# SERVICE INFO

## Design change for deflection pulley 532 0433 10

**Part No.:** 532 0433 10

Deflection pulley 532 0433 10, previous design (A) and new design (B)

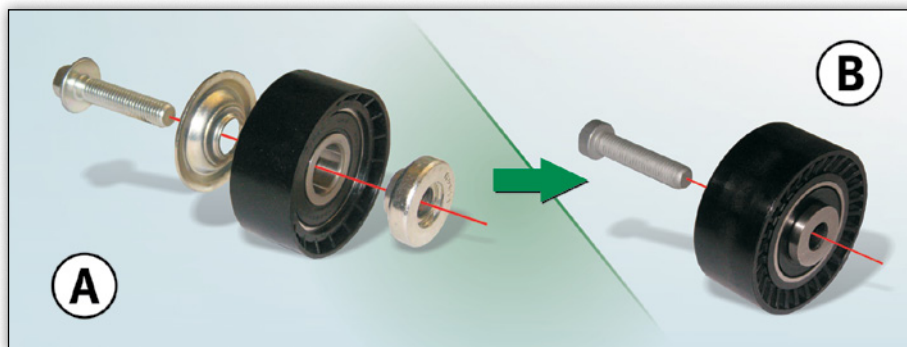
In the new design, the plate and spacer (Image 1, A) are no longer delivered as individual items as was previously the case. These components have been integrated in the new variant (Image 1, B) and are now an integral part of the deflection pulley.

During the transition period, we may have mixed stocks of both types. Both versions meet the relevant technical specifications and can be used without restrictions.

The deflection pulleys under A and B (see image) must only be mounted using the bolt provided.

Pulley A: M10x45, hex. bolt with collar  
Pulley B: M10x45, Torx bolt
